2 January 1980

ERRATA

FET Design Catalog

November 1979

Pages 4-12, 4-17

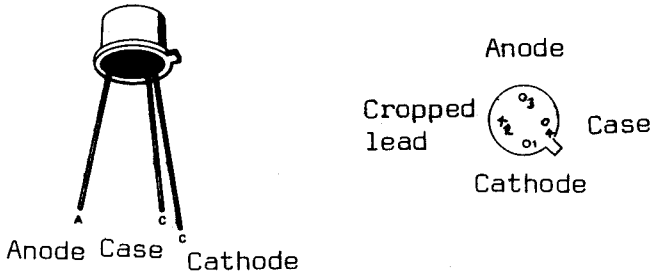
The pin-out for suffix -18 part numbers P-channel JFETs with offset leads to form TO-18/TO-106 pin circle should be amended to read D-G-S, as follows:

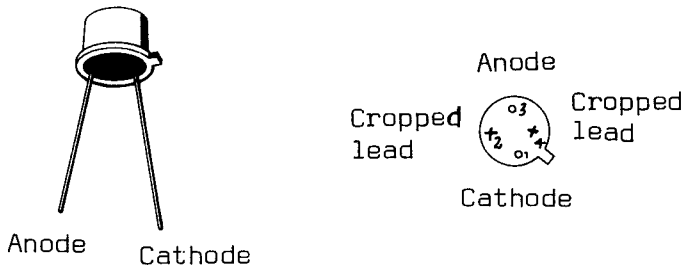
Pin-out for PAD 1, 2 and 5.
Amend illustration to read as follows:
